Private Plan Change Request (Ref: PC0003/23) – Coniston Park Ltd, Farm & Racecourse Roads, Ashburton

PART 1 - Further information

PART 3 – Comments Provided by Council Officers for Future Reference

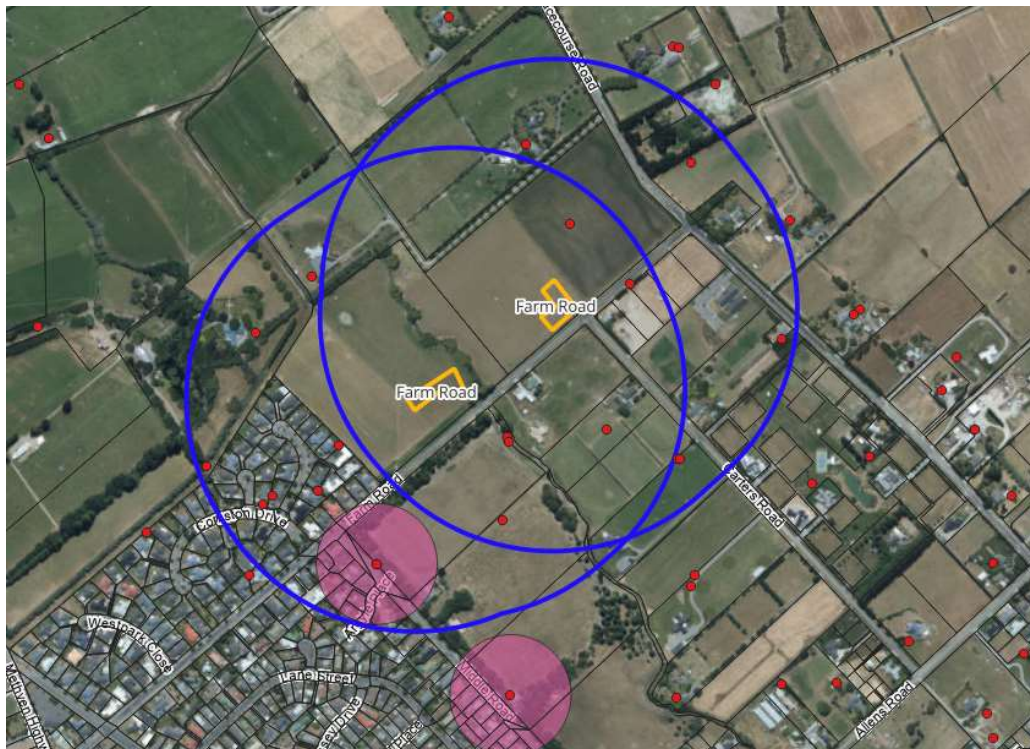
- The Council's global consent requires a 'capture zone' analysis, as described in the consent conditions. A 365m buffer is required for rapid soakage systems, which is approximately shown below.
